ALERT SERVICE BULLETIN

212-20-162

SUBJECT: TAILBOOM LEFT HAND FIN SPAR CAP P/N 212-030-447-117, INSPECTION OF.

Figure 1. Spar cap inspection.

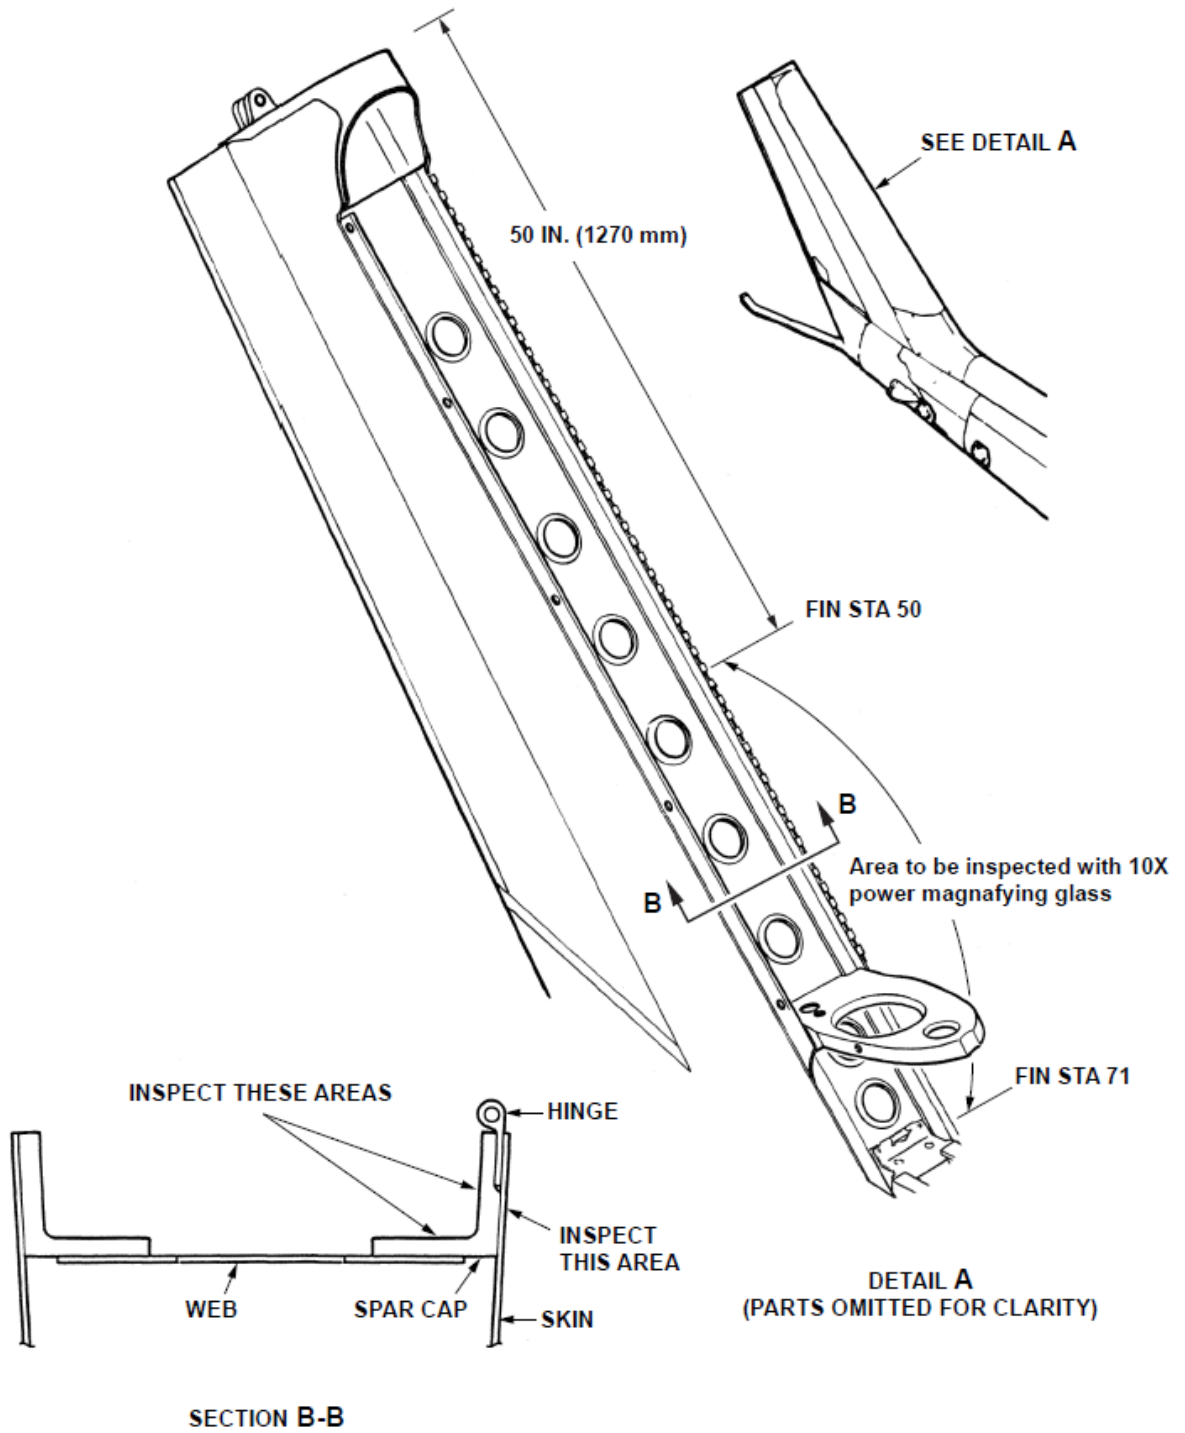
Bell has received a report of a fractured fin spar cap P/N 212-030-447-117. The crack occurred at vertical fin station (F.S.) 71 through the first rivet hole attaching the skin 212-030-099-105 to the spar cap. If undetected, the fin spar cap cracking may lead to additional structural damage. This bulletin introduces a 100 flight-hour inspection of the affected area of the fin spar cap using 10X magnifying glass.

1. Prepare the helicopter for maintenance.
2. Gain access to the spar cap angle by removing the 42-degree gearbox cover and opening the vertical fin driveshaft cover.
3. Clean exposed surfaces of spar cap to facilitate inspection.
4. Inspect both flanges of the spar cap between F.S. 50 and F.S. 71 using 10x magnifying glass and a bright light for cracks, loose rivets and other damage (Figure 1).
5. Inspect the exterior of the fin skin in the area in contact with the spar cap for cracks, loose rivets and/or distortion.
6. If no cracks or other damage is found, close the driveshaft cover, reinstall the 42-degree gearbox cover and return the helicopter to service.
7. If a crack or other damage is found, contact Product Support Engineering before further flight:
